DATE: 11.12.2019
TO: ProTrak
FROM: Mitesh Baxi
Traffic Engineering

■ **CAPE FEAR SOLAR SYSTEMS [TRC Plan Review]**

Initial Review Note

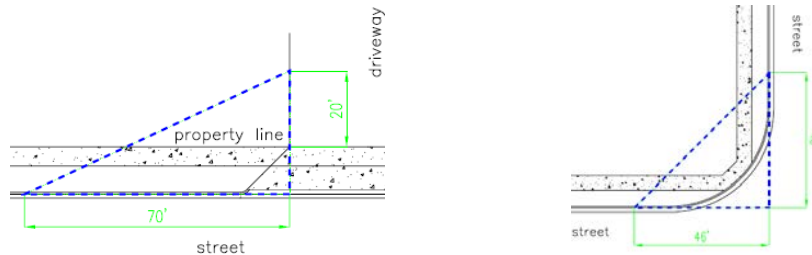
This section of S Front St is a NCDOT State Maintained Street. It is the Applicant’s responsibility to coordinate directly with NCDOT to determine if any driveway permits/ revisions/ review processes are required. Contact NCDOT at 910-398-9100. Please note additional comments may be forthcoming once coordination occurs.
